Clearance Publish

Clearance Computation Specification

**AT602167MQ - MUON
BARREL CHAMBERS
DETAILED, SECTOR 15**

**VHB_0001 - CENTRAL PAIR OF FEET
B - DETAILED MODEL FOR
STANDARDS**

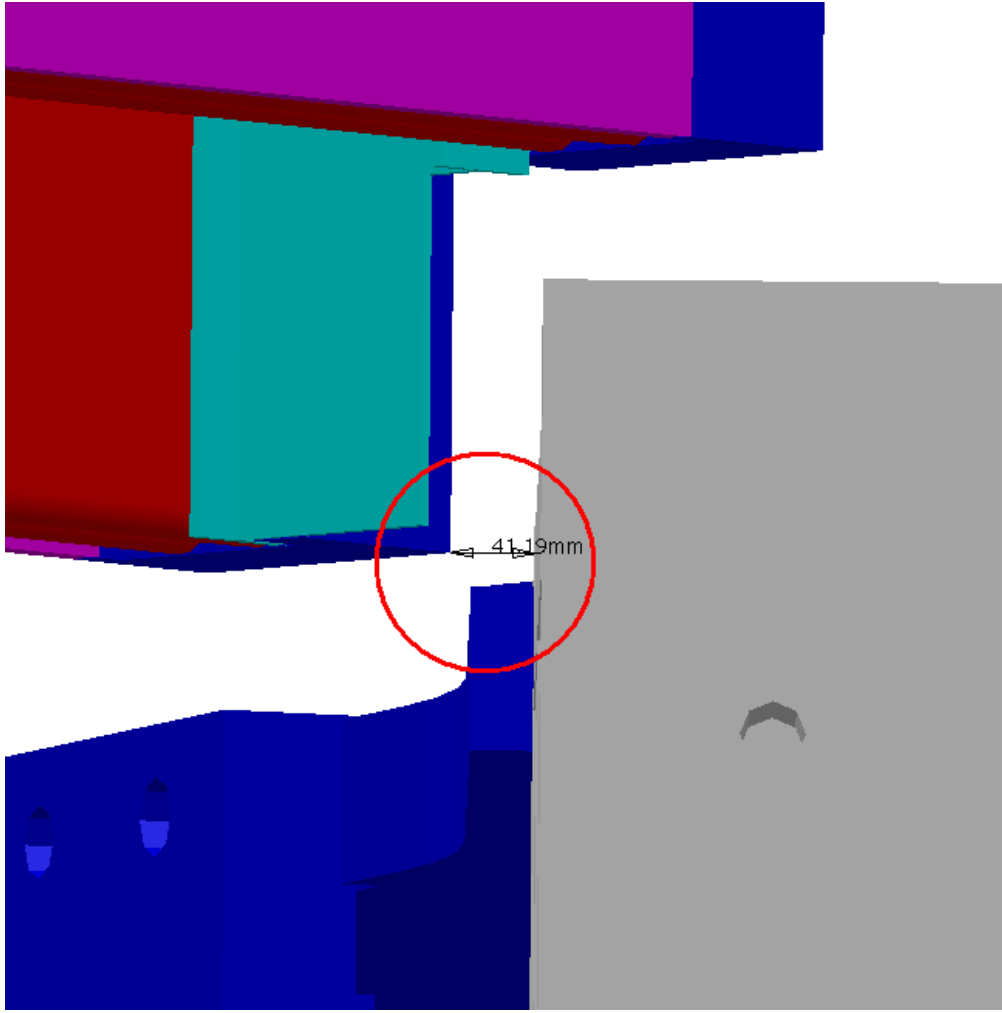
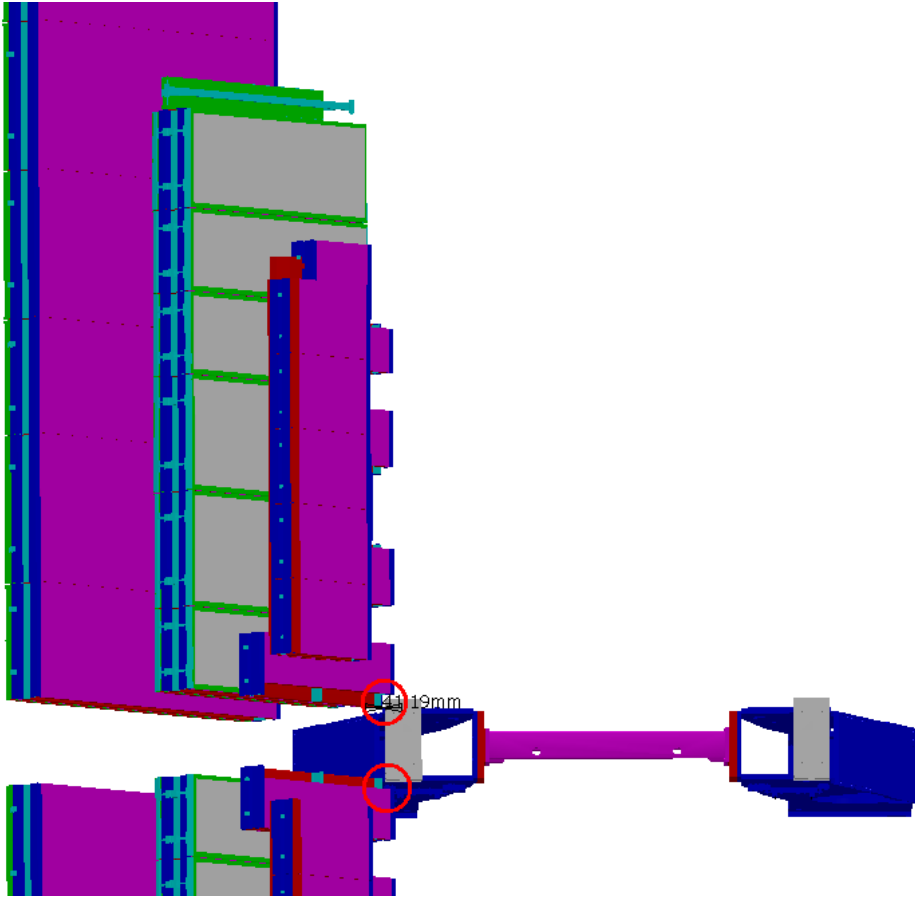
Not Relevant

Olga: Accepted

**NTB_0003 - TB WARM STRUCTURE -
SIMPLIFIED 3-D OBJECT**

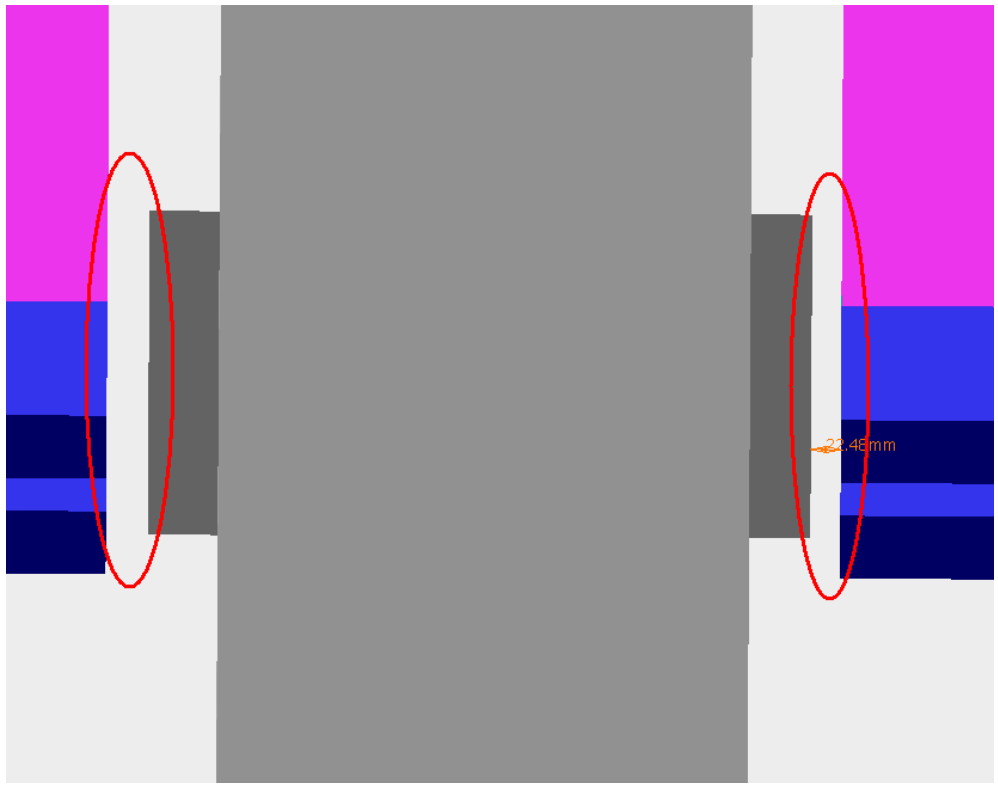
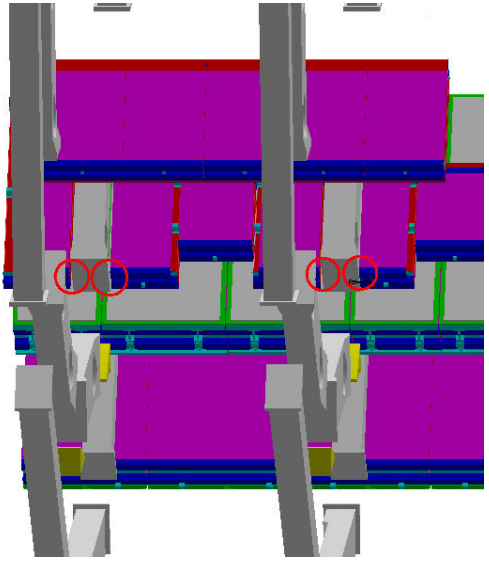
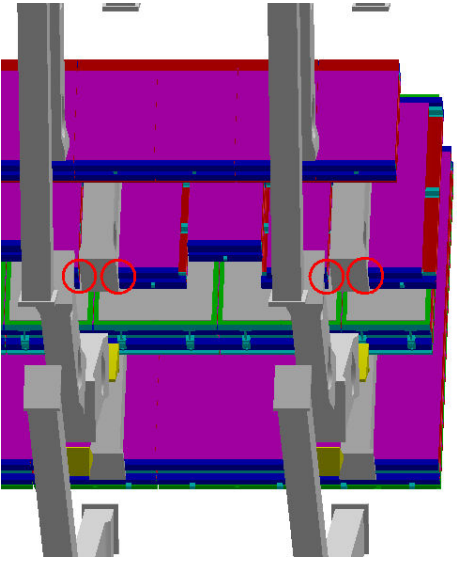
Clearance	22.5 mm		
	$\Delta X \approx 0$	$\Delta Y \approx -22.5$	$\Delta Z \approx 0$

Warning

**NTB_0005 - TB WARM STRUCTURE -
RING OF THE VOUSOIRS, STRUTS**

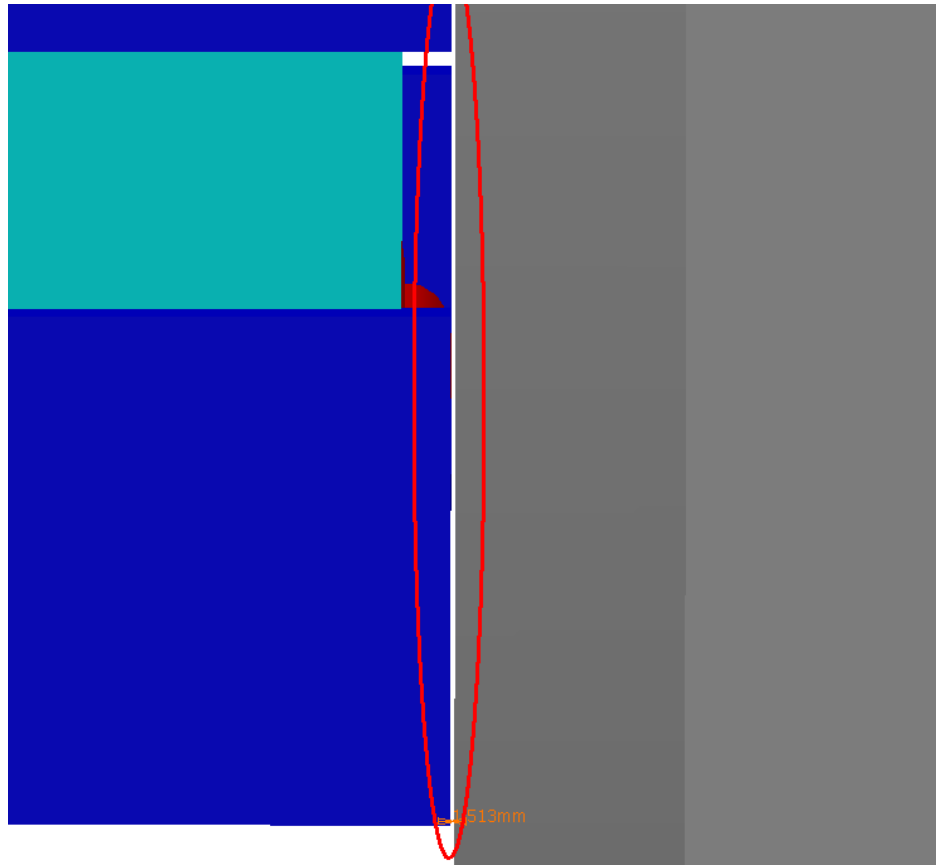
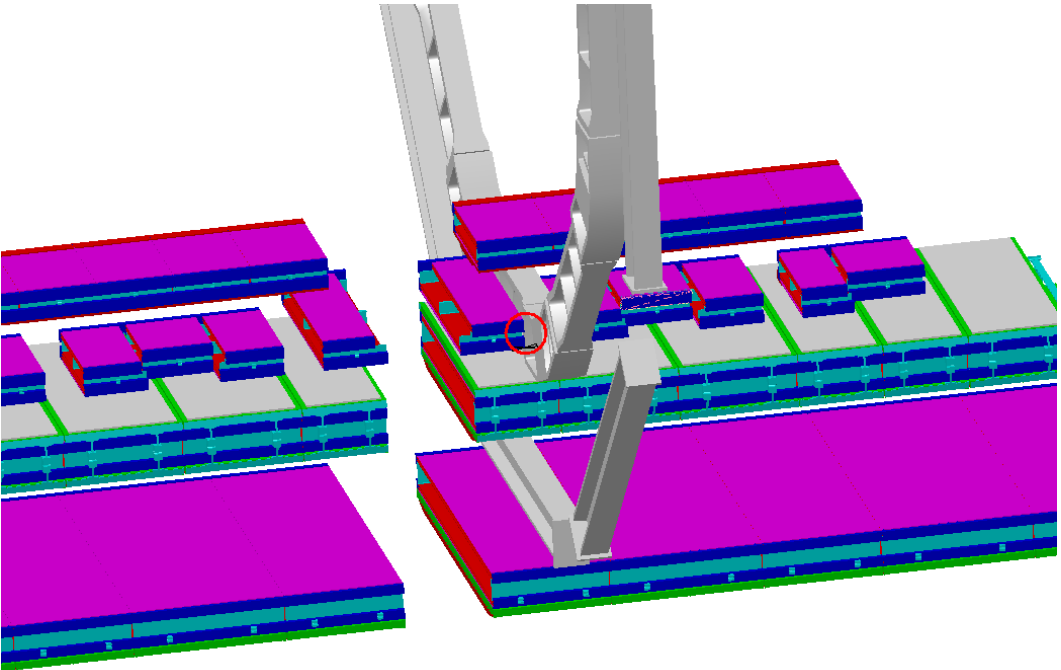
Clearance	1.5 mm		
	$\Delta X \approx 0$	$\Delta Y \approx 1.5$	$\Delta Z \approx 0$

Warning

Tatiana: Check with VTB

Lasha: I have checked with VTB, cutout exists.
Clearance is 27mm.
